**Development Application: 27 Church Street, Camperdown**

**File No.: RD/2017/1426/A**

### **Summary**

**Figure 13: Review plans - Ground floor plan**

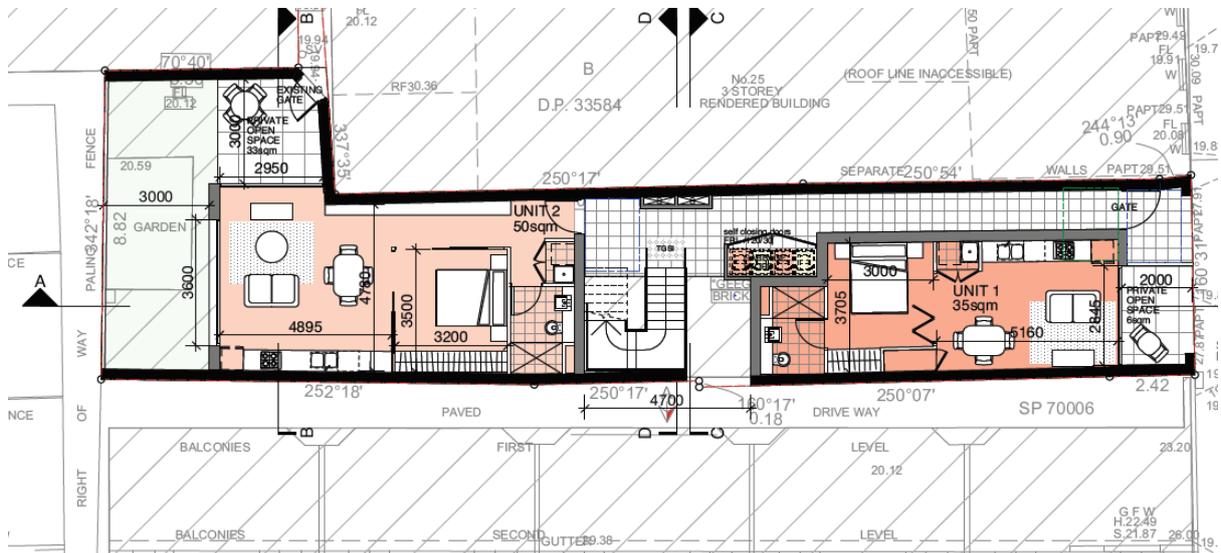
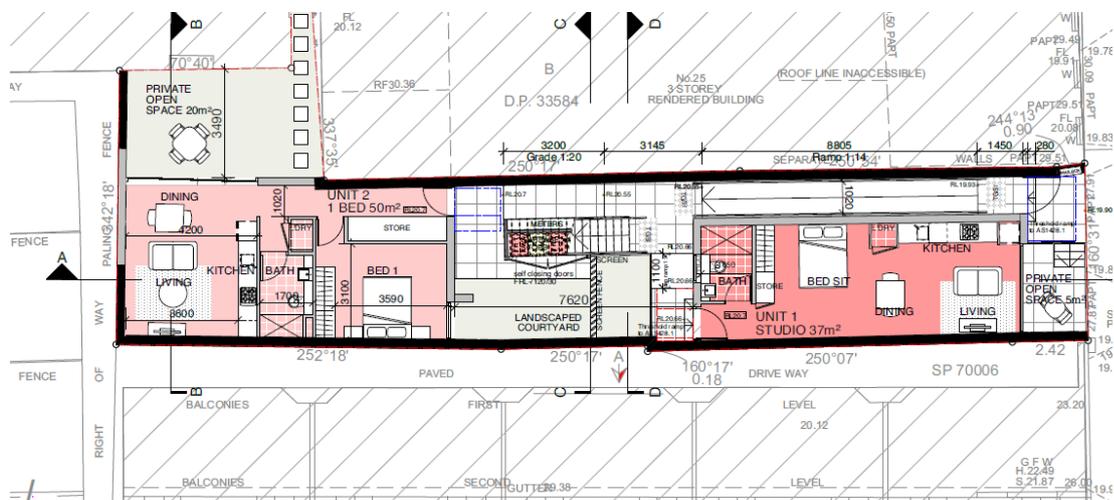
20. It is considered that the amended proposal does not satisfy the requirement of being substantially the same. In particular the amended proposal:
- (a) results in a different built form that alters the building footprint and extends to the rear boundary;
  - (b) presents as a two storey building to the street with a third level set back as opposed to a three storey building with an attic level above;
  - (c) provides a different configuration of space between buildings;
  - (d) introduces a new roof top open space to front building; and
  - (e) has different apartment configurations and external access arrangements.
21. A comparison between the refused plans and amended review plans are provided in Figures 12 to 25 below.

27. The Apartment Design Guide (ADG) requires 12m building separation between habitable rooms. The application proposes 7.62m separation between the front and rear parts of the building. This is likely to result in unacceptable visual and acoustic privacy impacts to the rooms that face these voids. The provision of the garbage storage room at the bottom of the void also contributes to acoustic and odour impacts.
28. The rear apartments are oriented to the north, with 3.49m building separation to the neighbouring property at 28-32 Mallet Street, which is currently a warehouse built to the full site boundaries. This does not satisfy the ADG requirement for 9m separation between habitable and non-habitable rooms.

**Response** - The application maintains a southern boundary wall so that the void will not impact upon neighbouring properties. As discussed above, the void results in privacy impacts to the occupants of the site.

Figure 15: Review plans - Level 1 floor plan

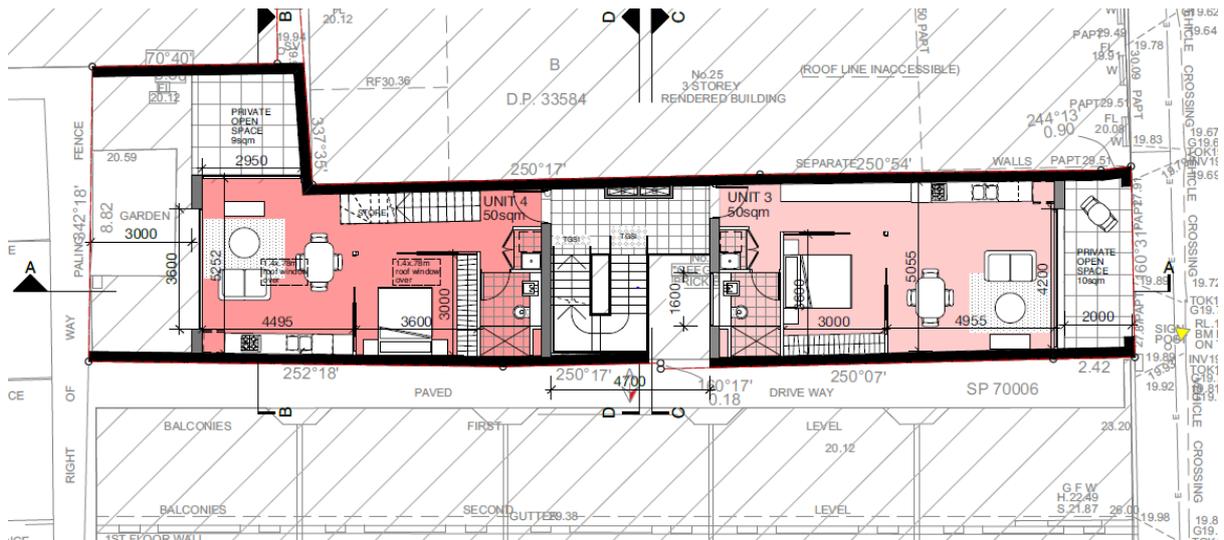
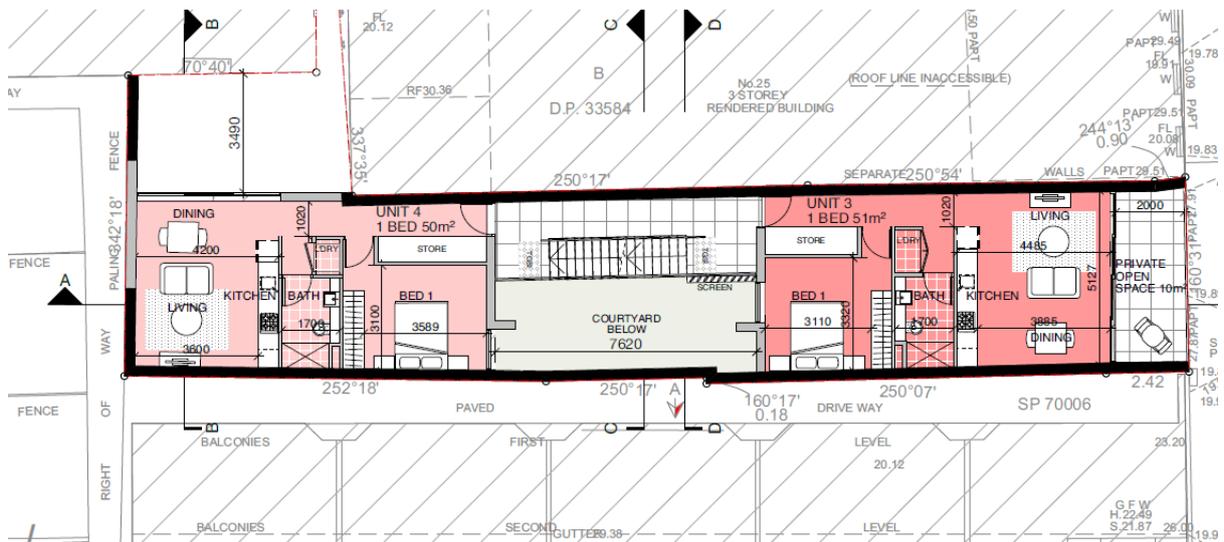
30. Unit 4 is not provided with any private open space, whilst Unit 1 is provided with only a small front balcony of 5sqm, which is less than 15sqm per apartment required by the ADG for ground level apartments.

Figure 17: Review plans - Level 2 floor plan

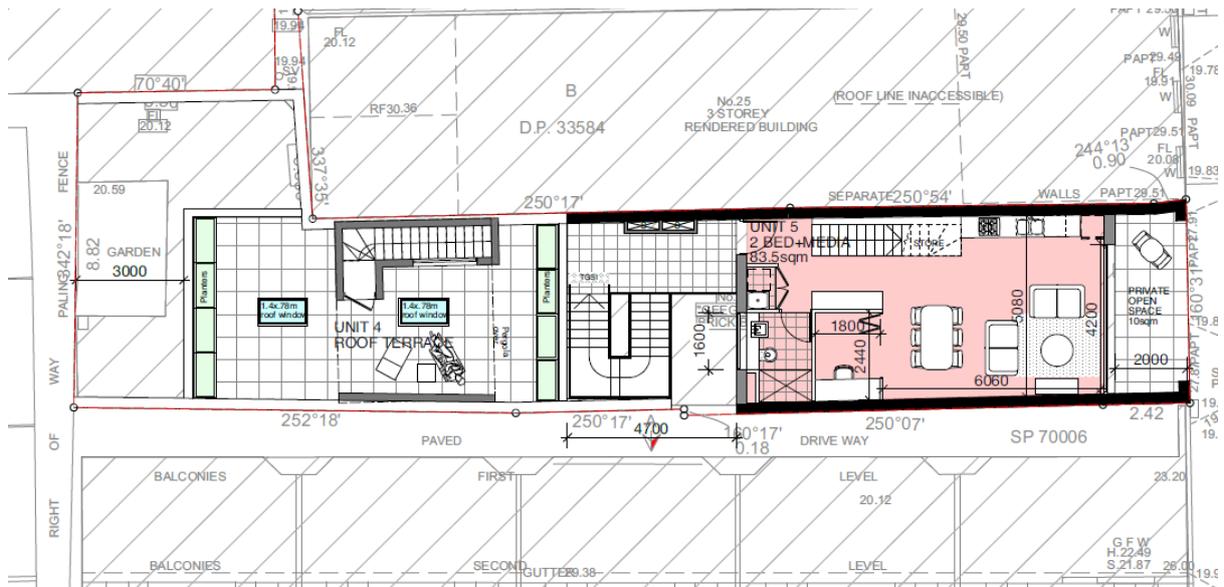
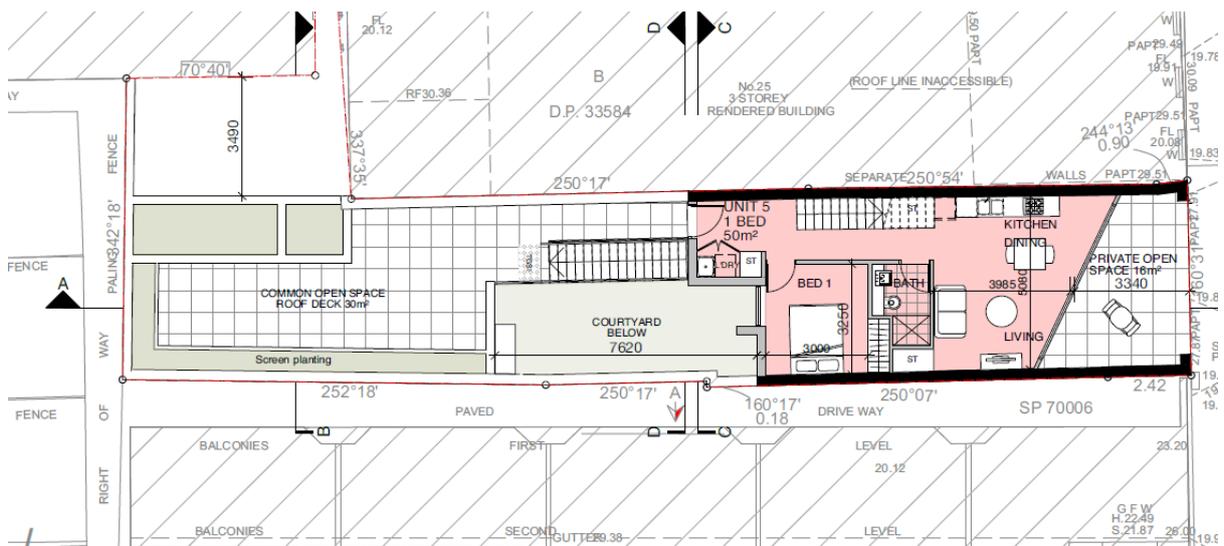
29. The amended plans provide a new area of communal open space area replacing the private roof terrace of Unit 4. The communal roof terrace is undersized, being 28.4sqm, whilst the ADG requires 25% of the site area equating to 50.7sqm. It is located so that it results in visual and acoustic privacy impacts to neighbouring properties.

Figure 19: Review plans - Level 3 floor plan

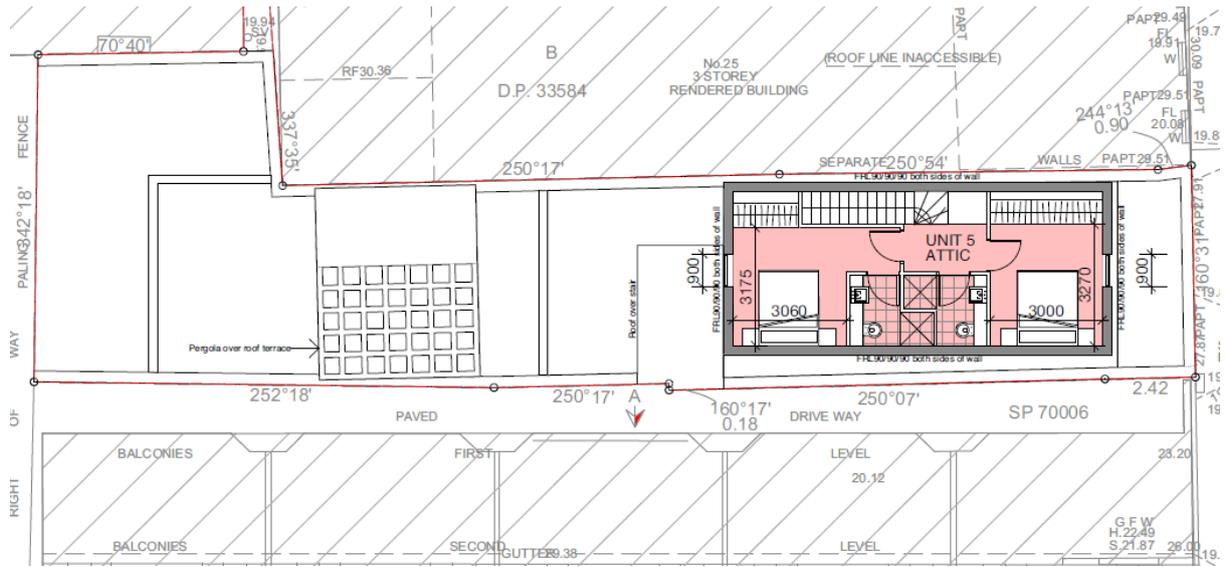
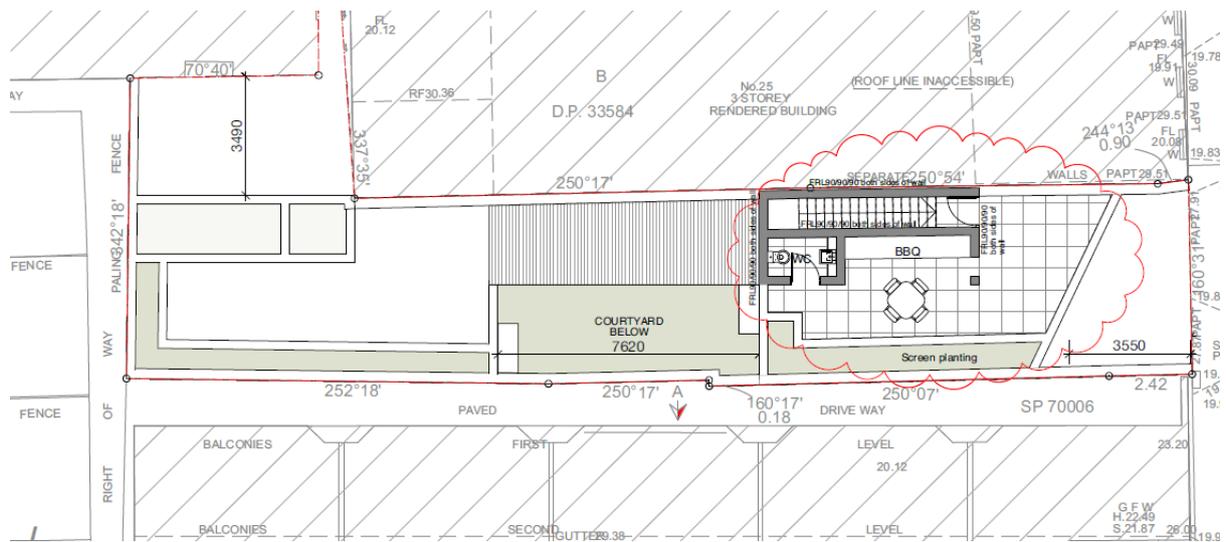
(ii) To 29-31 Church Street from the roof terraces.

**Response** - The review proposal does not propose a fourth storey or attic. This has been replaced with a private roof terrace including bbq, bathroom and stairwell.

Figure 23: Review plans - West elevation

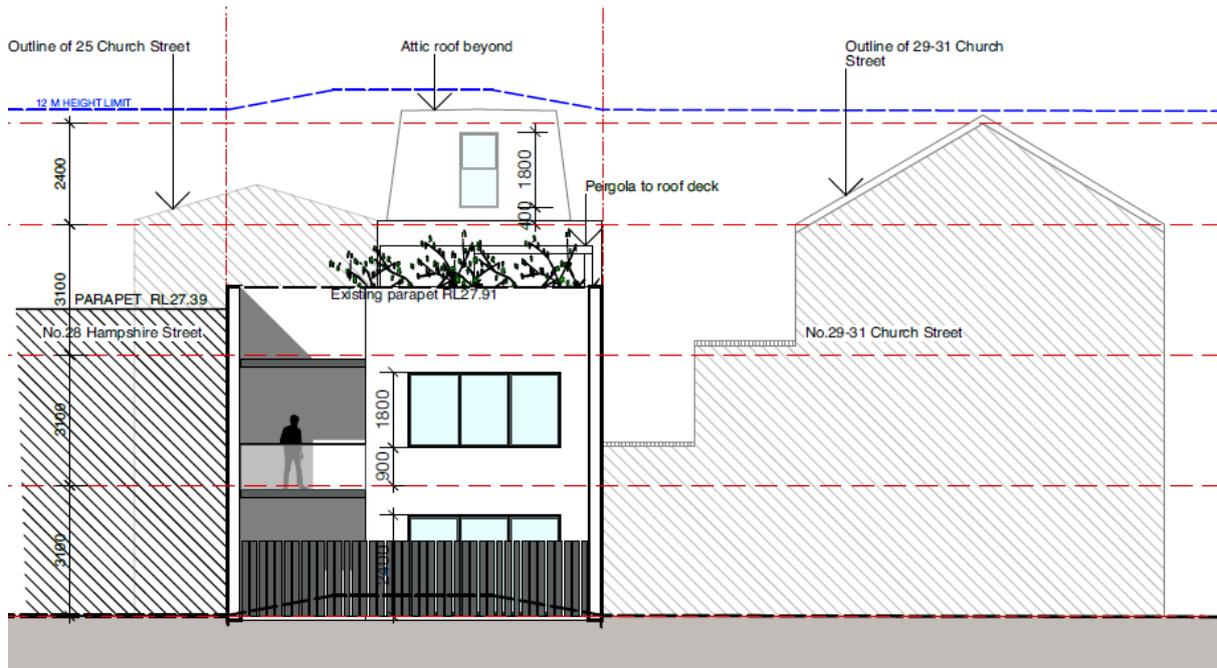
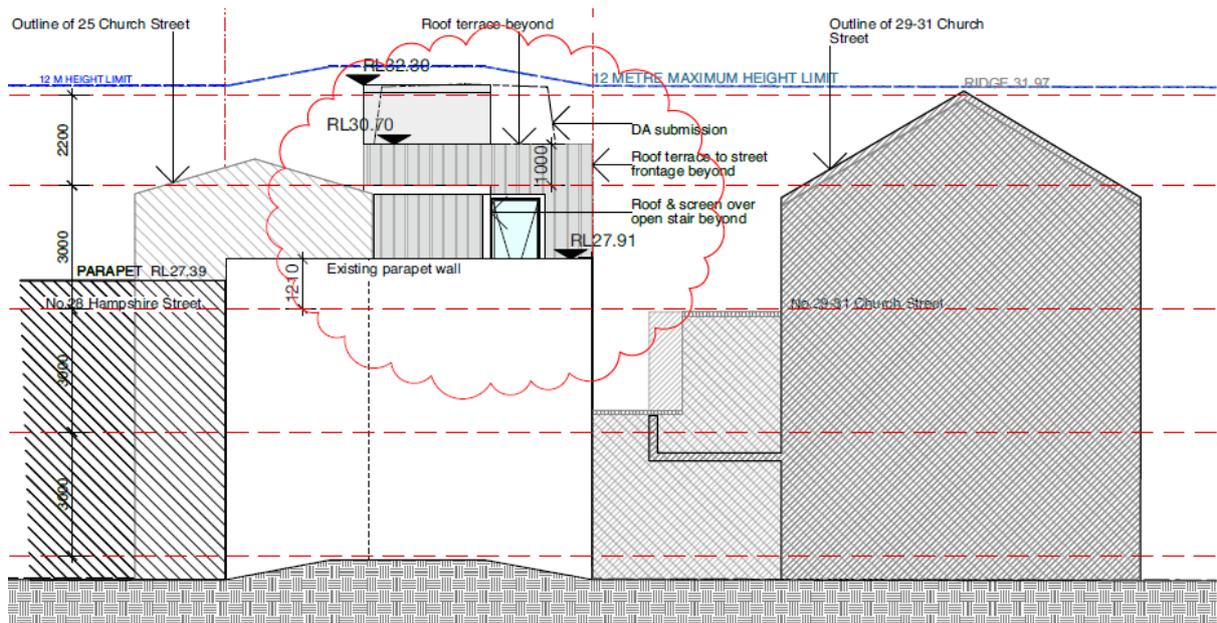
(i) From the west elevation from windows and roof terraces.

**Response** - It is considered that the proposal will result in unreasonable privacy impact to neighbouring properties and is not supported. The site is separated by approximately 6.7m to the dwellings on Mallett Street and by 4.5m to the second level of 29-31 Church Street.

Figure 25: Review plans - South elevation

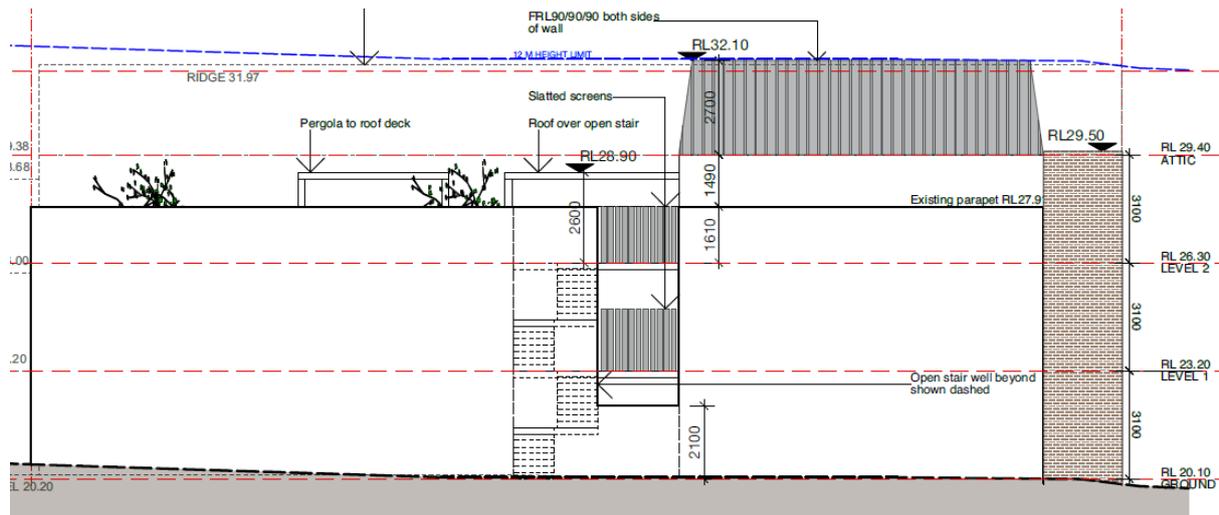
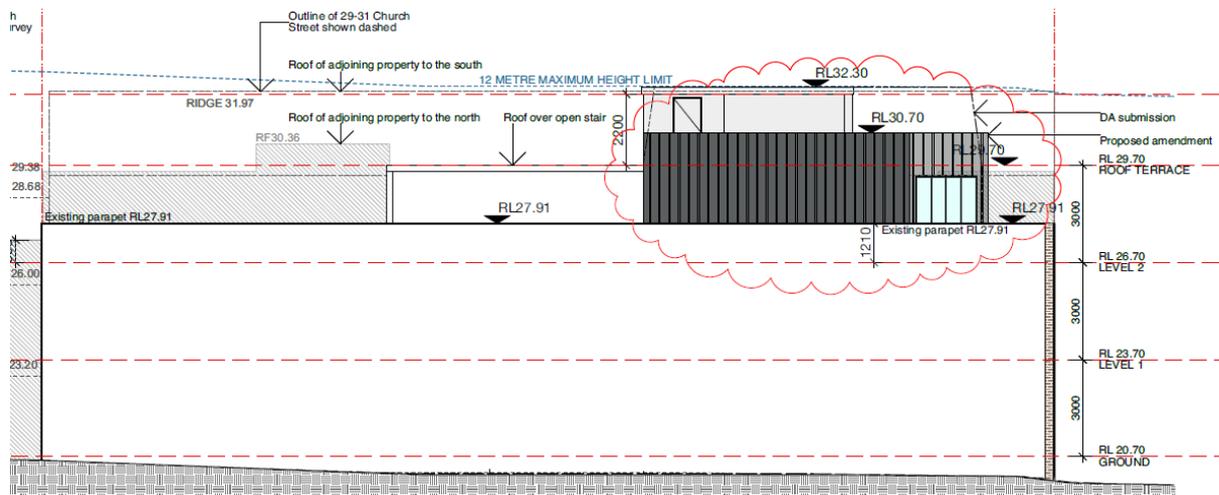
34. The amendments to the proposal have removed the fourth storey and provided a splay to the third storey to improve the solar access to the five units of the neighbouring site at 29-31 Church Street.

35. These units currently receive over 2 hours of direct sunlight to living room windows at midwinter. The amendments have improved solar access to some units, however Unit 3 does not achieve the minimum 2 hours of direct sunlight to 1sqm of living room window at midwinter as required by the ADG. This results in adverse amenity impacts to the neighbouring development.
